AMENDMENT NO. 05 TO INVITATION FOR BIDS FOR

Replacement of Chiller and Cooling Tower Accessories at Eight (8) Metro-rail Stations:

IFB-FQ18102/KKB

Solicitation FQ18102/KKB; Replacement of Chiller and Cooling Accessories at Eight (8) Metro-Rail Stations: DC, MD, and VA RFI Log Responses RFI Responses/Clarifications-RFI No. 53 thru 64

Figure 27, Field Control Wiring Diagram

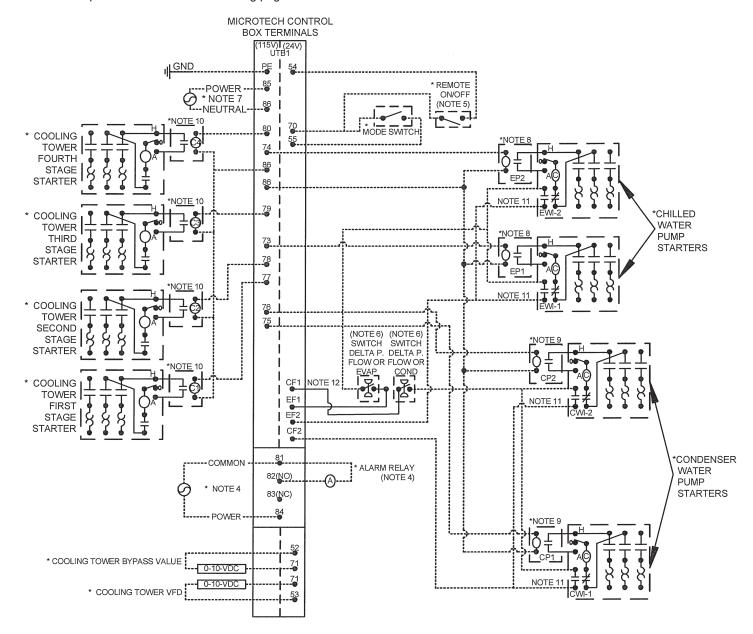
DESCRIPTION DELETE SUBSTITUTE Section 15900A, HVAC, Section 15900A, HVAC, Added Chiller Control Panel, Figure 27 Instrument and Controls Instrument and Controls Pages 15900A--6 thru. Pages 15900A--6 thru. Field Control Wiring 15900A-15 15900A-17, Amendment No. 5 Diagram, and Field Wiring Diagram Notes

Field Wiring Diagram Notes

- Compressor front end box is factory mounted and wired. All line side wiring must be wired in accordance
 with the nec and be made with copper wire and copper lugs only. Use only copper supply wires with
 ampacity based on 75°C conductor rating. Main power wiring between the front end box and compressor
 terminals is factory installed.

- Minimum wire size for 115 VAC is 12 ga. for a maximum length of 50 feet. If greater than 50 feet refer to
 Manufacturer for recommended wire size minimum. Wire size for 24 VAC is 18 ga. All wiring to
 be installed as NEC class 1 wiring system. All 24 VAC wiring must be run in separate conduit from 115
 VAC wiring. Wiring must be wired in accordance with NEC and connection to be made with copper
 wire and copper lugs only.

- 2. For optional sensor wiring see unit control diagram. It is recommended that DC wires be run separately from 115 VAC wiring.
- 3. A customer furnished 24 or 120 VAC power for alarm relay coil may be connected between Unit Terminal Board (UTB1) terminals 84 power and 81 neutral of the control panel. For normally open contacts wire between 82 & 81. For normally closed wire between 83 & 81. The alarm is operator programmable. Maximum rating of the alarm relay coil is 25 VA.

- 4. Remote on/off control of unit can be accomplished by installing a set of dry contacts between terminals 70 and 54.
- 5. Thermal dispersion flow switches for the evaporator and condenser are factory mounted as standard and provide adequate flow loss protection. If desired, additional flow or pressure differential switches can be customer supplied, mounted and wired as shown. A factory wired evaporator flow switch is connected between EF1 and EF2, and a condenser flow switch between CF1 and CF2. Any additional devices must be wired in series with them.

- 6. Customer supplied 115 VAC 20 amp power for optional evaporator and condenser water pump control power and tower fans is supplied to Unit Control Terminals (UTB1) 85 power / 86 neutral, and equipment ground.

- 7. Optional customer supplied 115 VAC 25 VA maximum coil rated chilled water pump relay (EP1 and EP2) may be wired as shown. This optional will cycle the chilled water pump in response to chiller demand.

- 8. The condenser water pump must cycle with the unit. A customer supplied 115 VAC 25 VA maximum coil rated condenser water pump relay (CP1 and CP2) is to be wired as shown. Units with free cooling must have condenser water above 60°F before starting.

- 9. Optional customer supplied 115 VAC, 25 VA maximum coil rated cooling tower fan relays (C1 C2 standard, C3 C4 optional) may be wired as shown. This option will cycle the cooling tower fans in order to maintain unit head pressure.

- 10. Auxiliary 24 VAC rated contacts in both the chilled water and condenser water pump starters should be wired as shown.
